**VENETA PLANNING DEPARTMENT**  
**STAFF REPORT**  
**Federal Security Storage and Warehousing - City File No. SR-3-23**  
**Site Plan Review**

The request is for a Site Plan Review for a storage and warehousing facility.

**FEDERAL SECURITY  
SITE PLAN REVIEW**

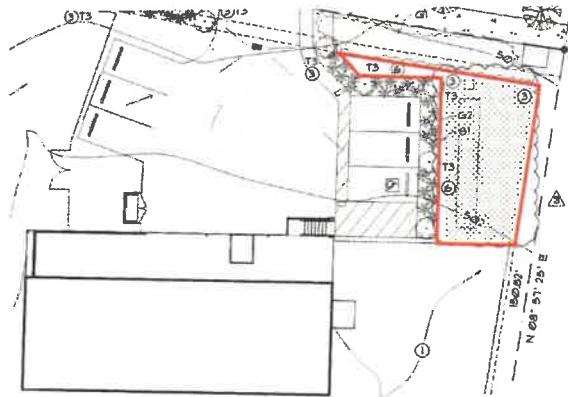
The applicant's landscaping plan generally meets the standards of VZDC Section 5.12 – Landscaping, but one area on the applicant's landscape is unclear about the proposed planting. See the image to the right of the applicant's site plan with the area in question highlighted in red.

The landscape plan does not identify what the groundcover species will be. A condition of approval has been added requiring the applicant to submit and receive approval of a final landscaping plan showing what groundcover species will be planted in this area.

8. Prior to beginning operations, the applicant shall submit and receive approval by the City of a final landscaping plan that shows, in addition to the proposed landscaping shown on Sheet L1.1 of the applicant's submittal, the trees, shrubs, and groundcover species that will be planted in the northeast corner of the site that is south of the front yard setback, west of the east property line, east of the east three parking spaces, and north of the north edge of the portion of the chain-link fence that is east of the existing building, in accordance with Section 5.12 of the Veneta Land Development Ordinance No. 493.

**1 HORIZONTAL CONTROL  
C2.1 UTILITY PLAN**

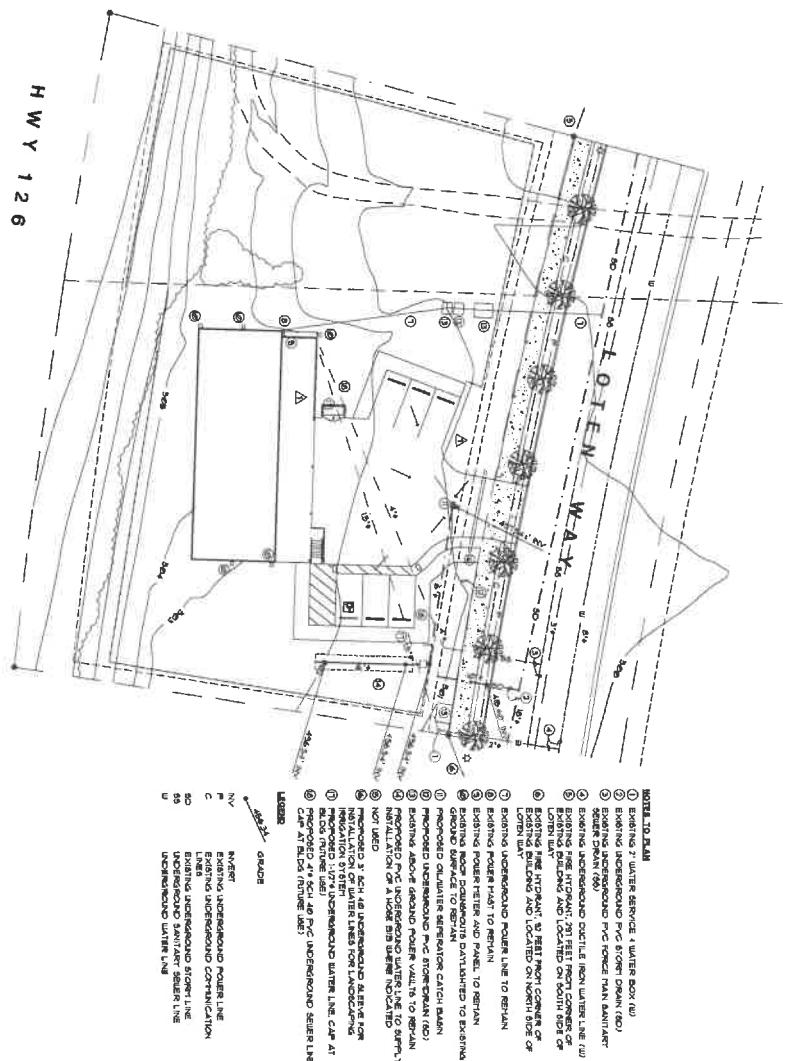
- 6) Notes 12 and 14 on Sheet C2.1 appear to be missing the PVC storm pipe that it is intended to refer to.

9. Prior to beginning operations, the applicant shall submit and receive approval by the City of a final utility plan that clarifies notes 12 and 14 on Sheet C2.1.
